Department of Energy
Washington, D.C. 20545

Docket No. 50-537
HQ:S:82:036

RESPONSES TO REQUEST FOR ADDITIONAL INFORMATION - POWER SYSTEMS

Reference: Letter, P. S. Check to J. R. Longenecker, "CRBRP Request for
Additional Information," dated March 16, 1982

Figure 8-2-11 PROPOSED TRANSMISSION LINE ROUTE OF THE CRBRP SITE AREA

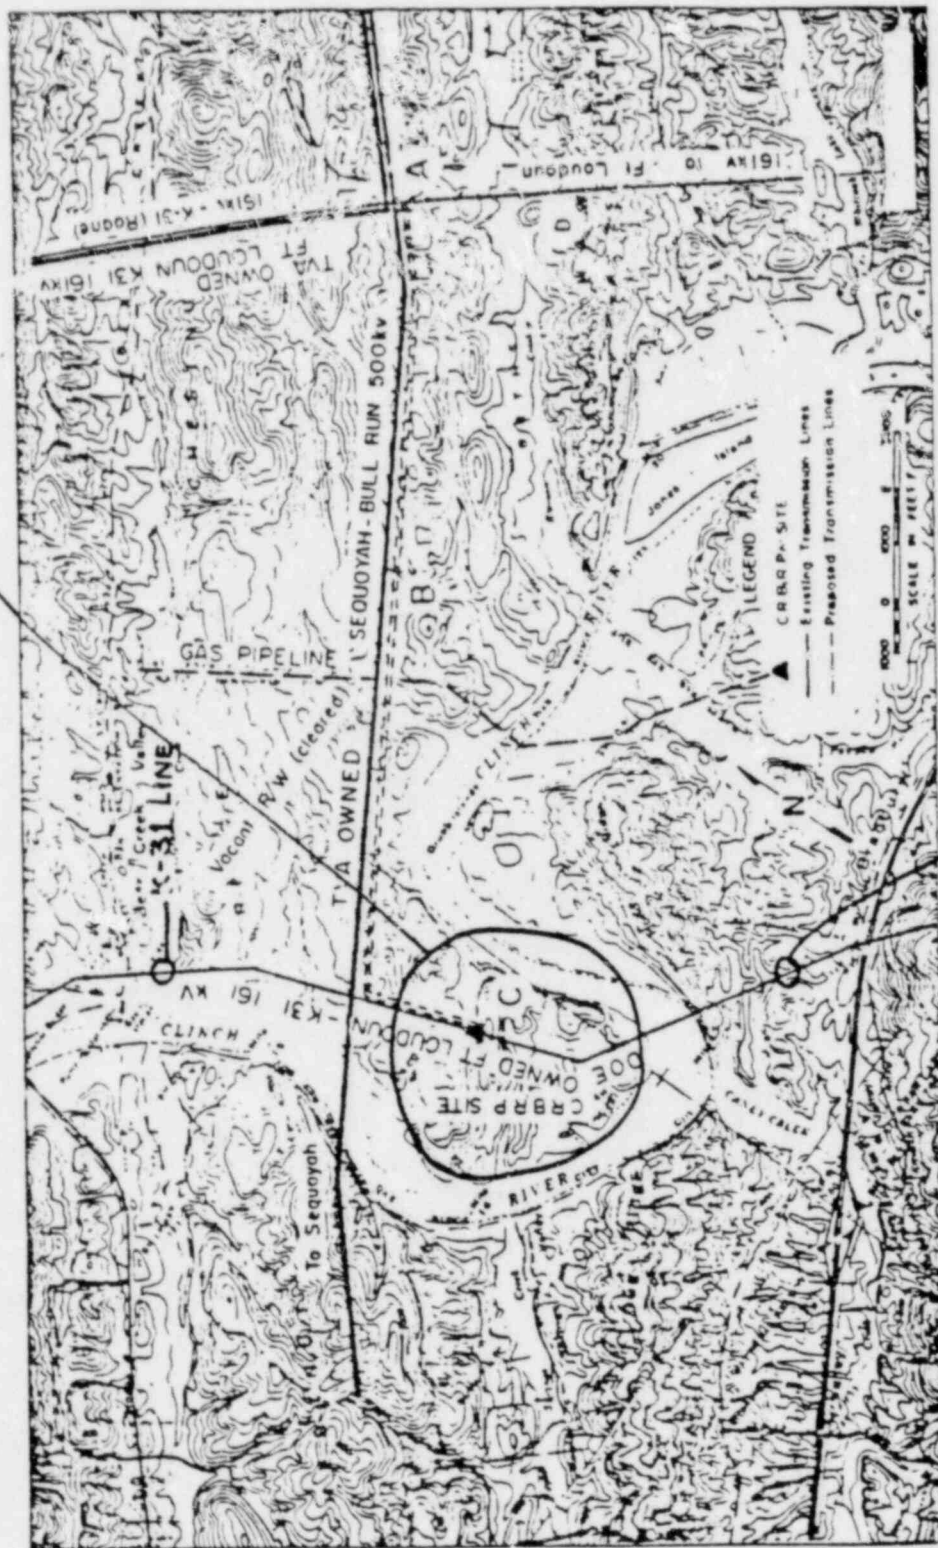
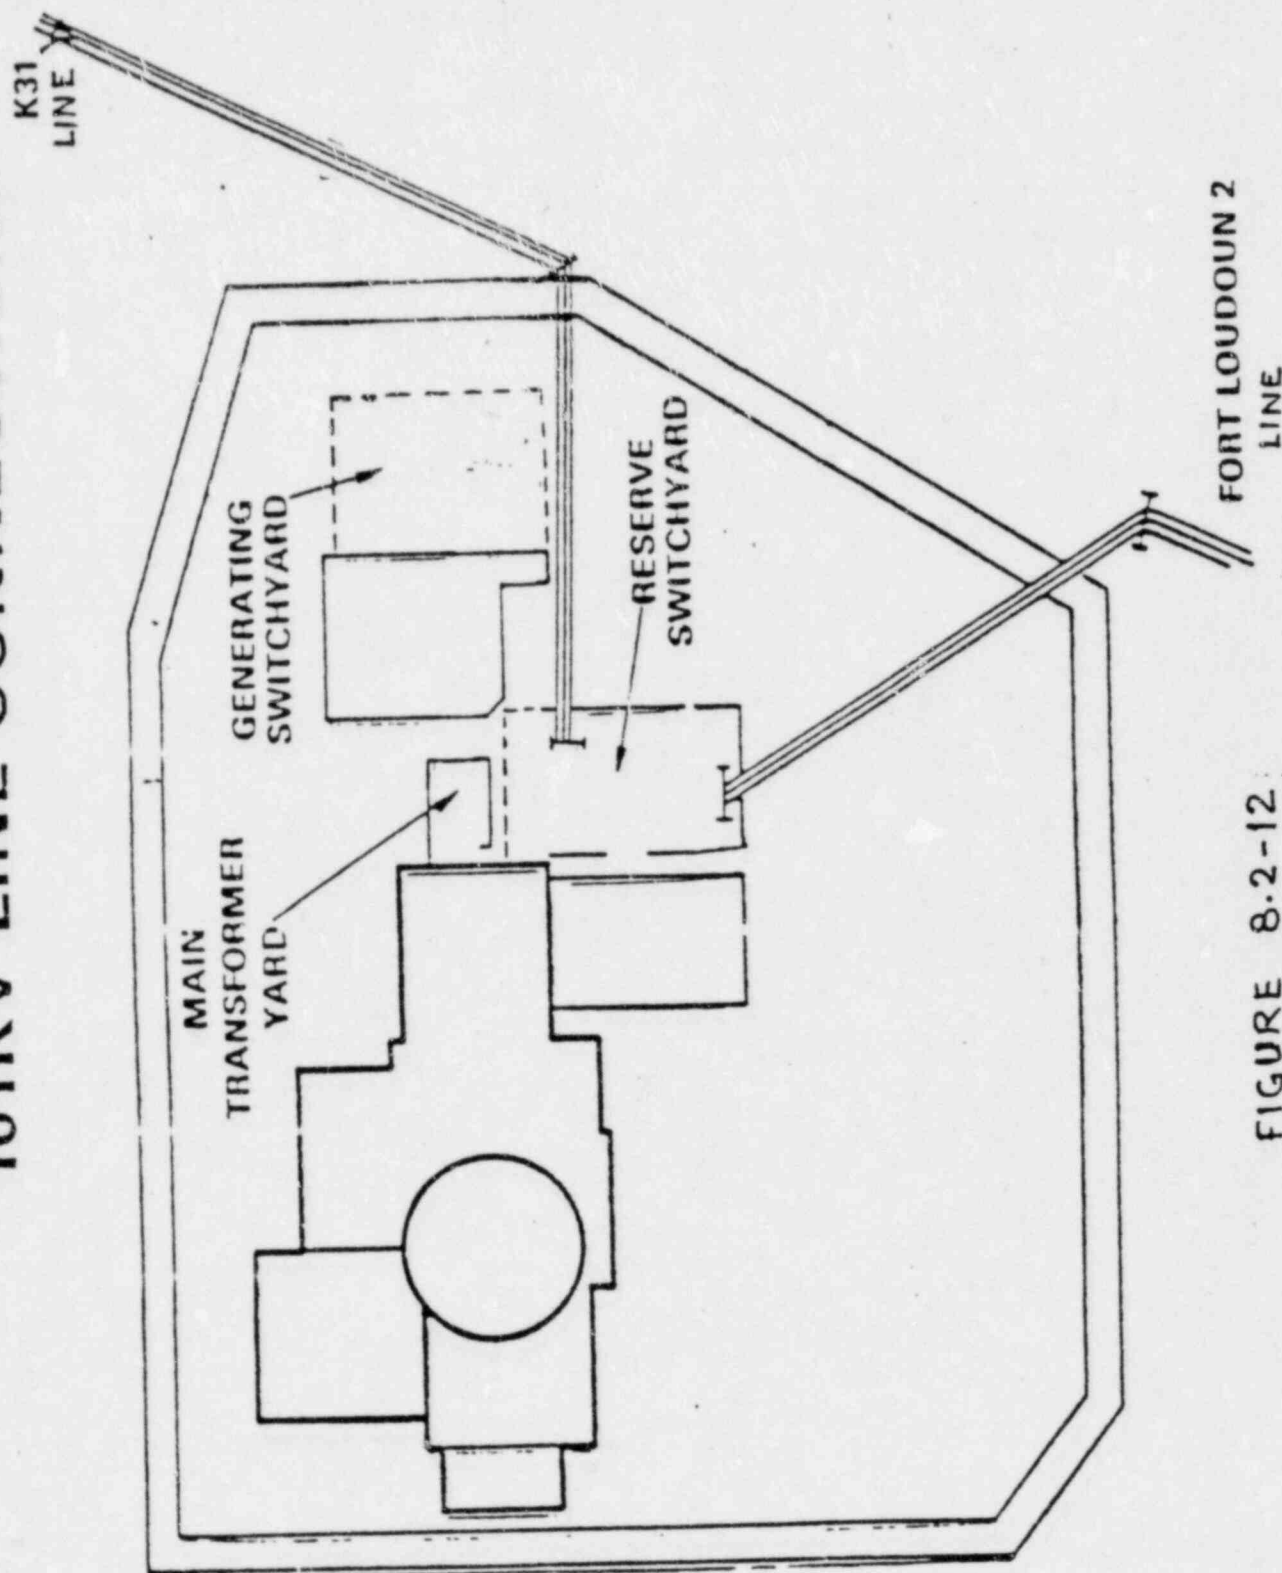
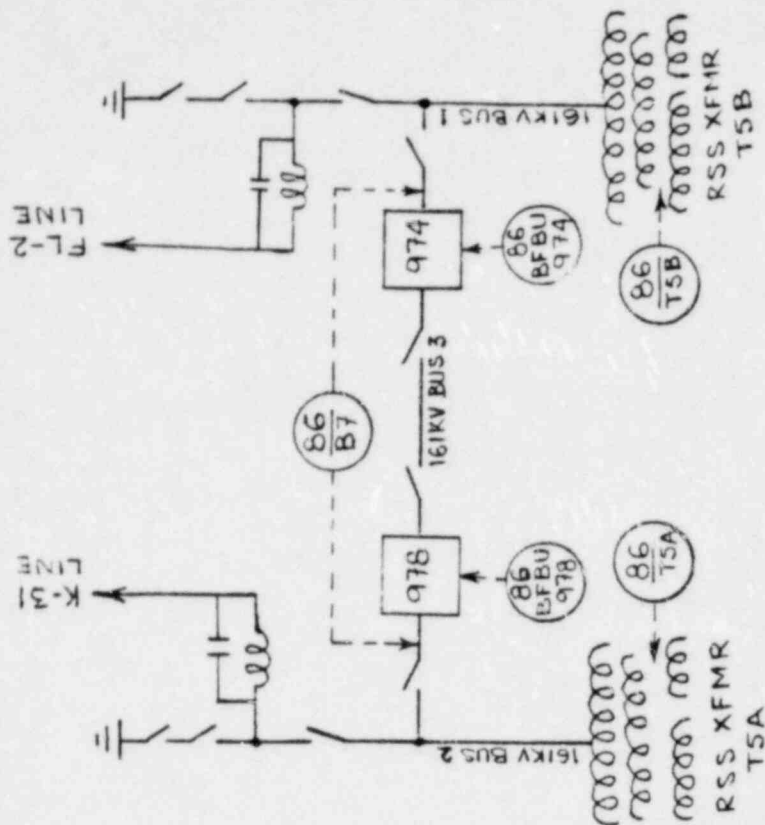
Provide physical layout drawings and/or additional description in the PSAR of the physical Independence to be provided between the offsite power circuits in proximity of the plant to the switchyards and from the switchyard to the Class 1E onsite power system. Also provide description of physical Independence between Class 1E and the offsite circuits protective relaying.

K-31 and Fort Loudoun-2 161kV transmission lines (both connected to the reserve switchyard of the CRBRP) provide the two physically Independent offsite power sources to CRBRP; details of their routing and construction in the proximity of the plant have been described in Section 8.2.1.1 and 8.2.1.3 of the PSAR. Further, in the proximity of the CRBRP:

1. at any one location no transmission line crosses over these two transmission lines simultaneously;
2. transmission lines are spaced sufficiently apart such that failure of one line does not affect the other line. (see Figures 8.2-11 and 8.2-12 attached).

FIGURE 8.3-6 CABLE TRAY SEPARATION

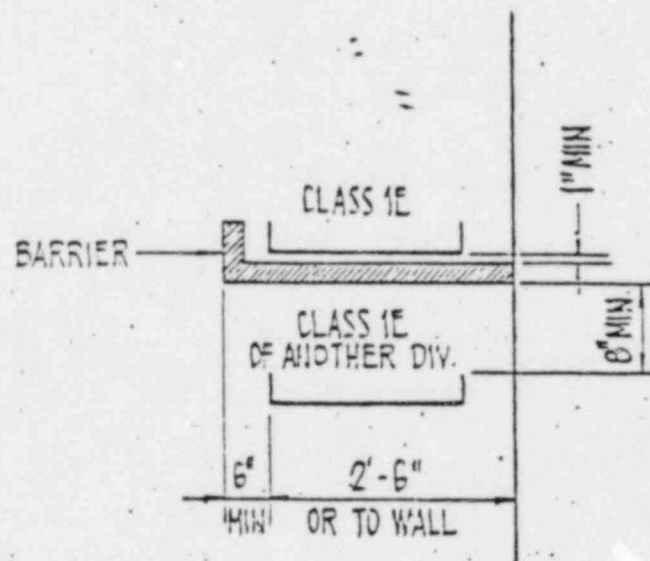
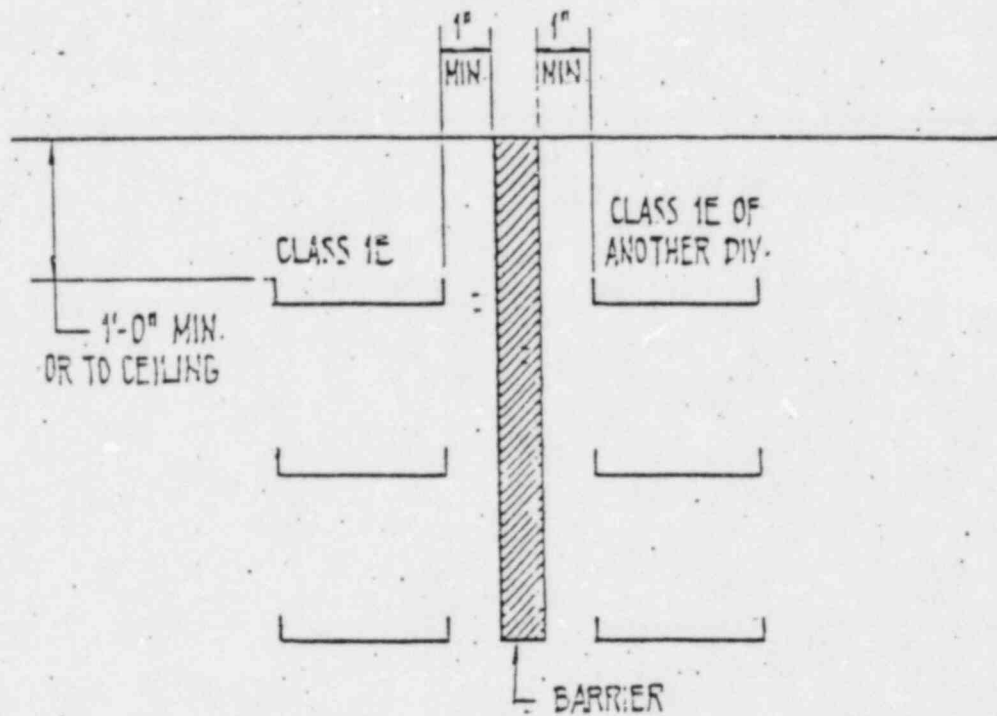
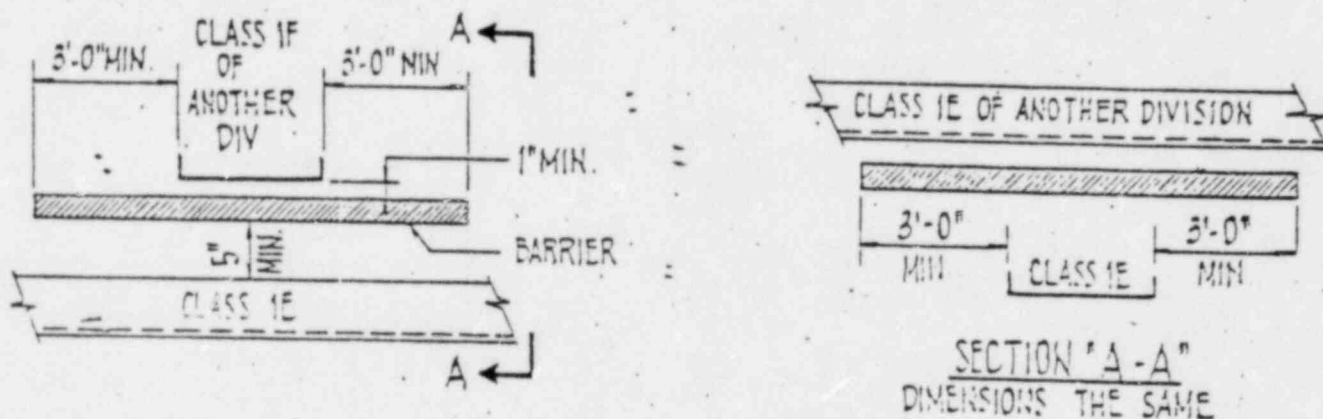
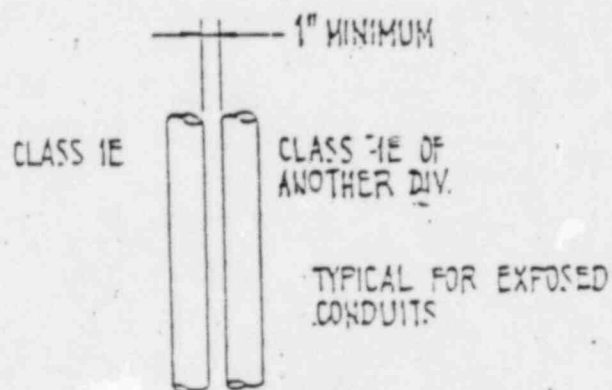
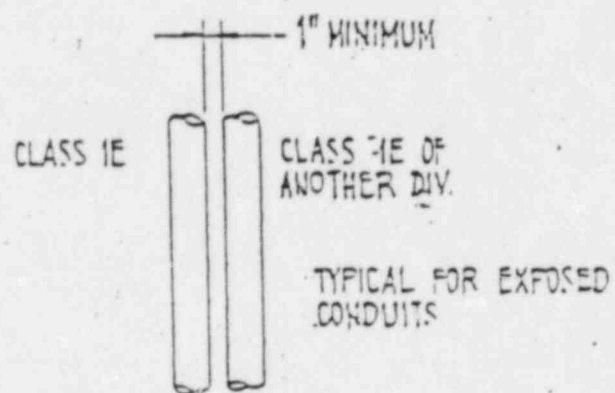
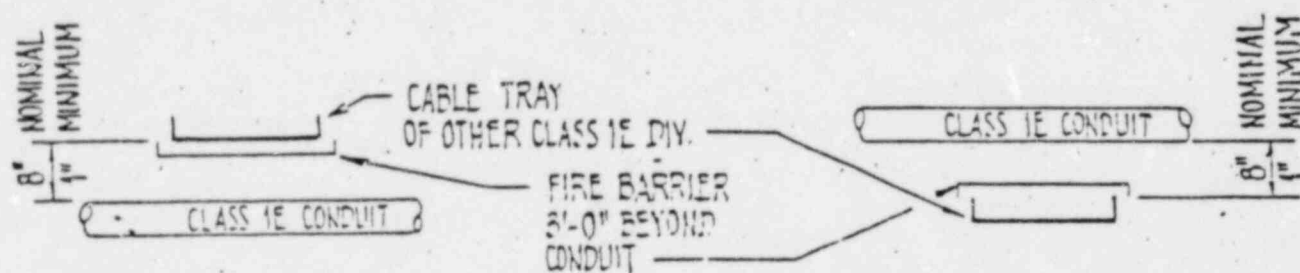
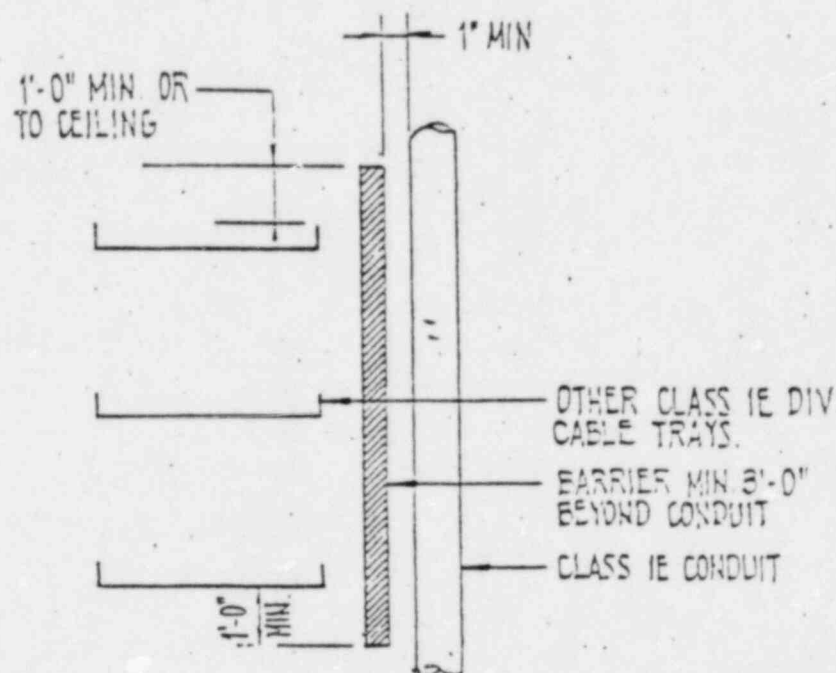
Section 8.3.1.2.14 of the PSAR indicates that physical separation of circuits and equipment comprising or associated with the Class 1E power system, Class 1E protection systems and Class 1E equipment, will be in accordance with criteria set forth in paragraph 8.3.1.4 of the PSAR. Separation criteria described in Sections 8.3.1.2.14 and 8.3.1.4 of the PSAR is not clear and does not meet the guidelines of IEEE Standard 384 and Regulatory Guide 1.75. For example, the PSAR indicates that non-Class 1E cables in panels will be separated from Class 1E cables so that they will not provide a combustion path between different divisions. Section 5.6.5 of IEEE Standard 384-1974 states that non-Class 1E cables shall be separated by six inches or a barrier. In general no criterion has been described for separation of Class 1E and non-Class 1E cables. Other examples include: (1) no criteria for separation between cables trays and conduits of another division, (2) confusing criteria for the separation of the third division (the design indicates there are three divisions but only two redundant divisions. Separation criteria refers to only two redundant divisions in many cases versus the three divisions), (3) confusing definition for associated cables, (4) no criteria for separation between associated cables and non-Class 1E cables, and (5) no criteria before and after an isolation device. Revise your PSAR description of physical separation of circuits to comply with the recommendations of IEEE Standard 384-1974 and guidance of R.G. 1.75 or justify noncompliance.

In Non-Hazard Zones, exposed conduits of different Class 1E divisions are routed as far as possible apart, preferably on opposite sides of the walls. Parallel routing of conduits of different divisions is avoided. If the design makes it unavoidable a minimum of one (1) inch spatial separation is provided between conduits of different Class 1E divisions as shown in Figure 8.3-6. When the safety related conduit cross or run parallel to another safety related tray the minimum horizontal and vertical clearance is the same as provided for cable trays of different Class 1E divisions. If this clearance is unavoidable, a barrier is provided between the safety-related conduit and cable trays of other Class 1E divisions as shown in Figure 8.3-6.

In Non-Hazard Zones, a minimum horizontal clear space of three feet is maintained between cable trays of different divisions as shown in Figure 8.3-6. If a horizontal clearance of less than three feet is unavoidable, a fire barrier is provided between the divisions as shown in Figure 8.3-6.

Vertical stacking of cable trays of different divisions is avoided wherever possible. Where cable trays of different divisions are stacked vertically, a minimum clear space of five feet is provided between the divisions as shown in Figure 8.3-6. If a vertical clearance of less than five feet is unavoidable, a fire barrier is provided between the divisions as shown in Figure 8.3-6.
